City of Sugar Hill Planning Staff Report **RZ 19-004**

DATE:November 12, 2019; Updated January 16, 2020.TO:Planning CommissionFROM:Planning DirectorSUBJECT:Rezoning RZ-19-004, 4359 Woodward Mill Road

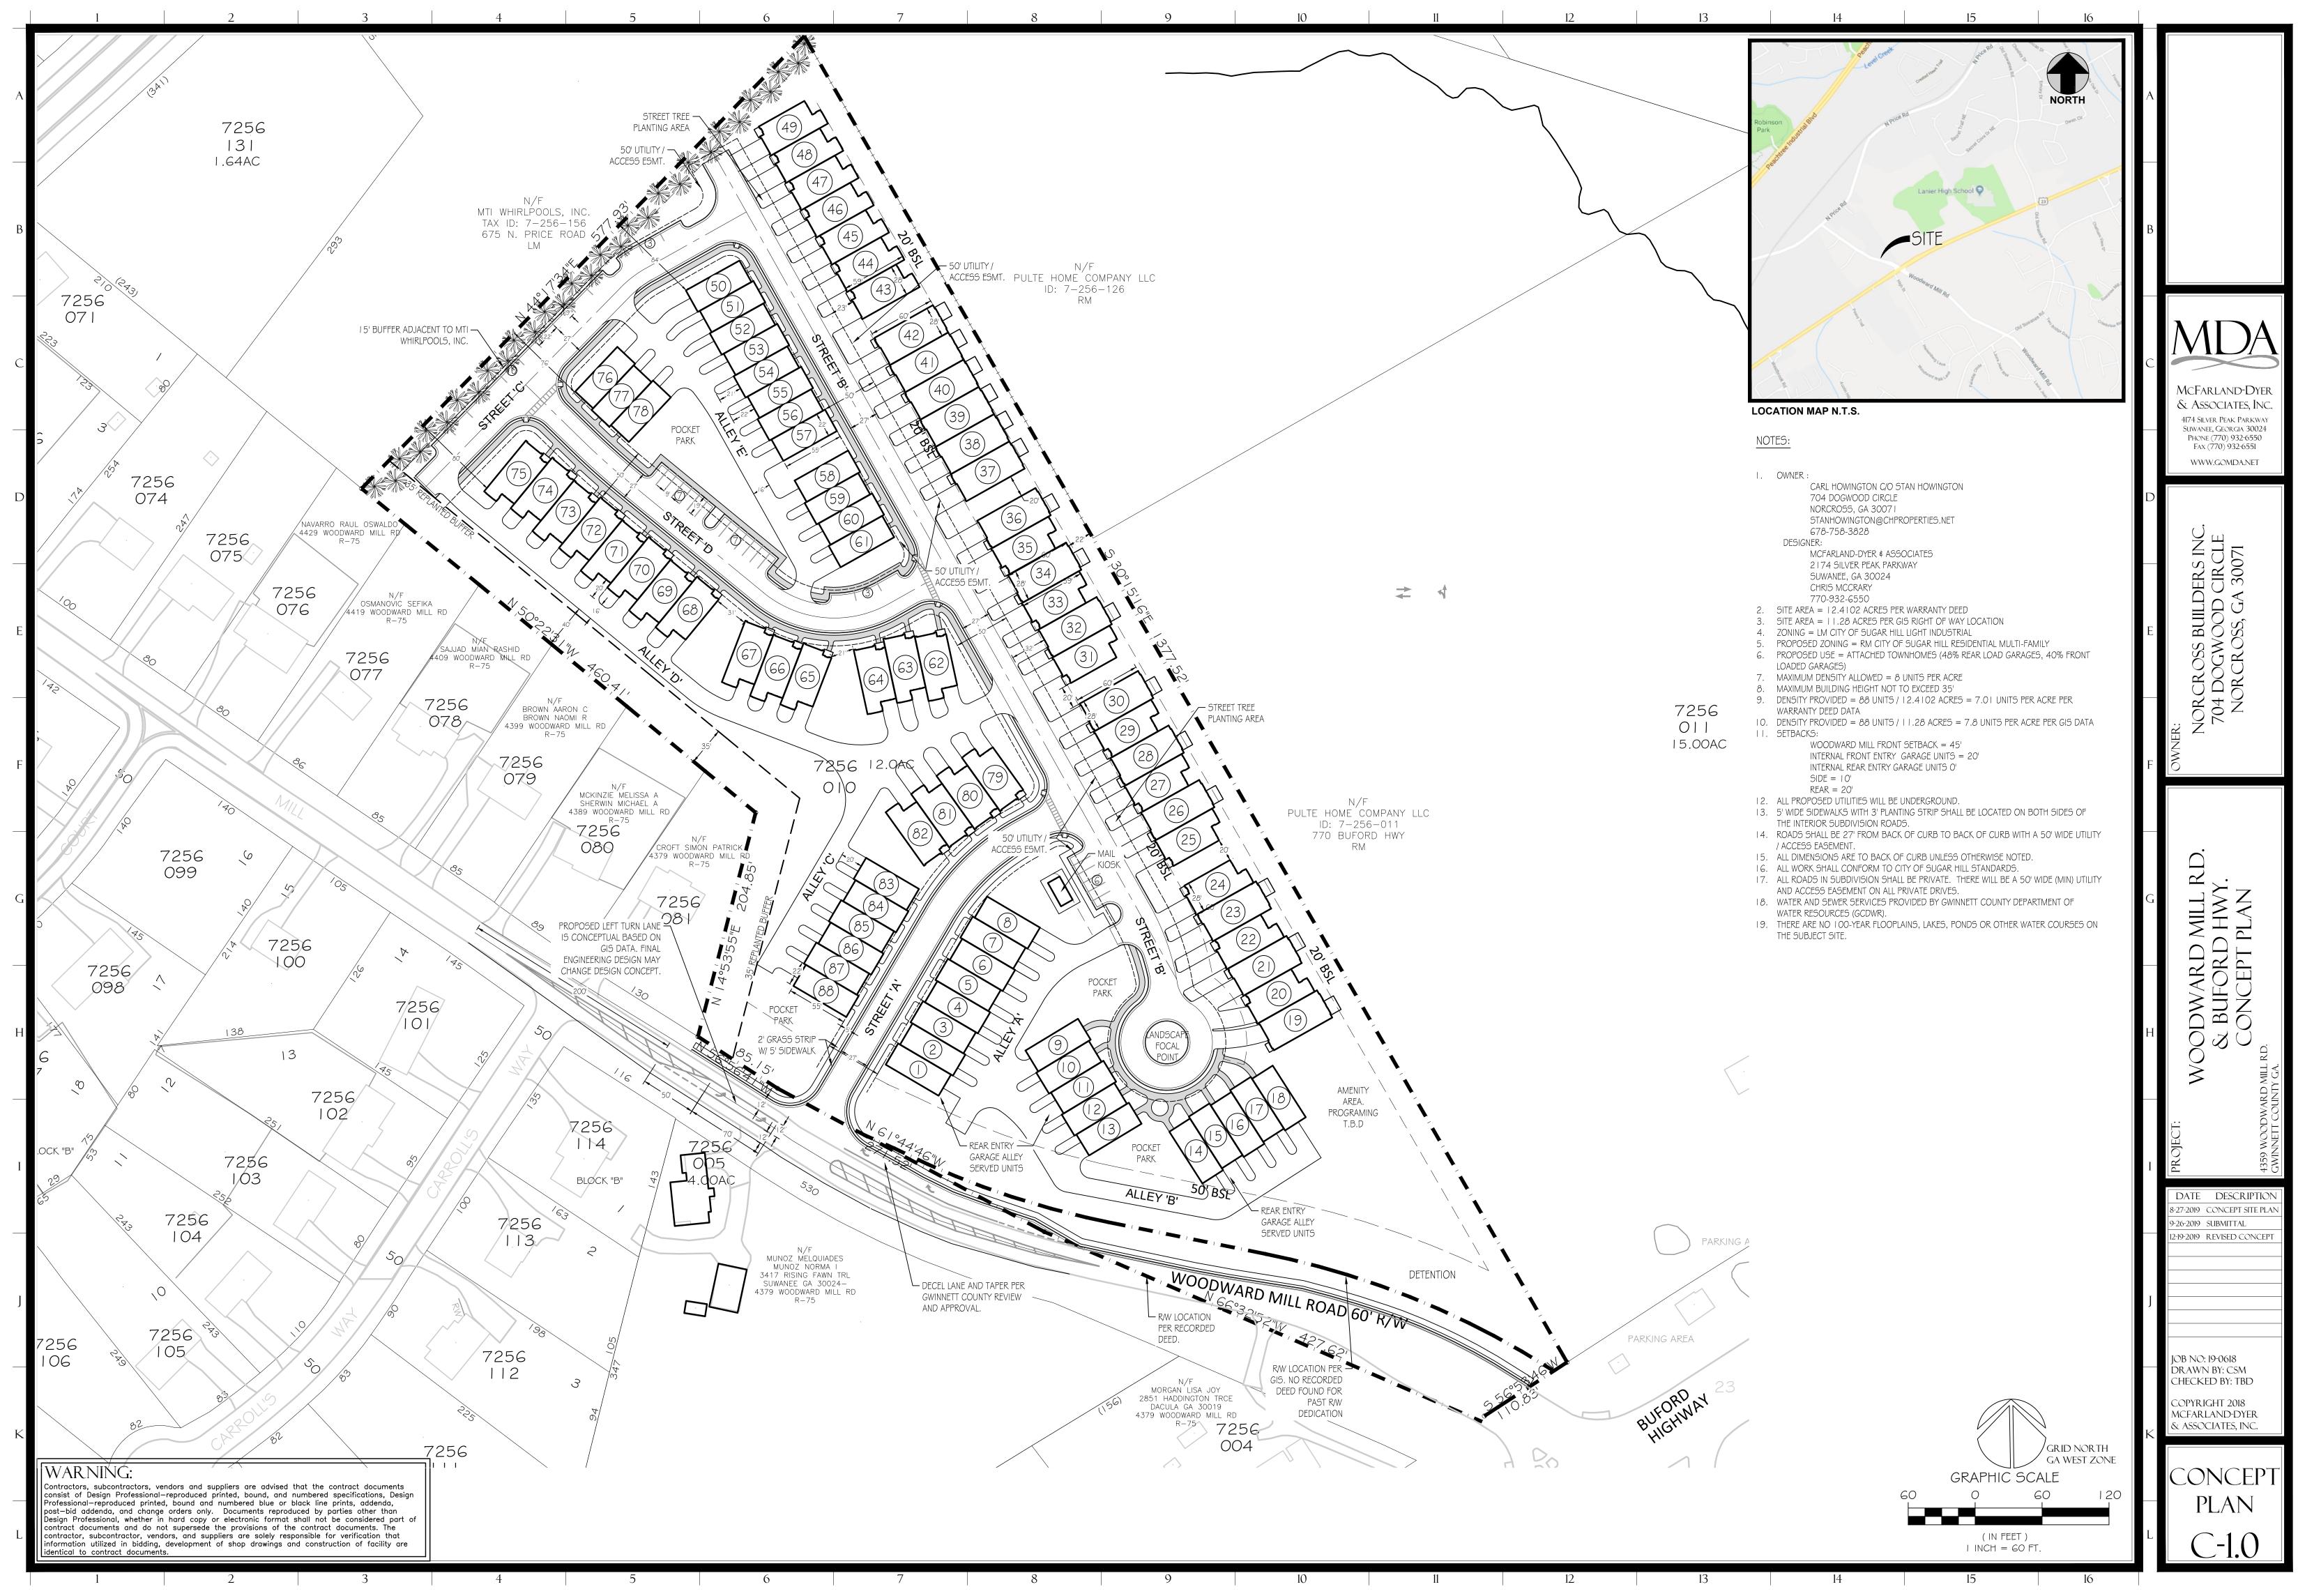
• <u>Applicant submitted an updated overall site plan along with plans showing</u> <u>alternative project access improvements including a left-turn lane, mini</u> <u>roundabout and single lane traffic circle on Woodward Mill Rd. The revised</u> <u>concept plans appear to be responsive to concerns voiced by area residents and</u> <u>representatives of MTI Whirlpools, Inc. pertaining to traffic congestion and</u> <u>safety, arrangement of buildings and landscaping along the subject property's</u> <u>northwest property line.</u>
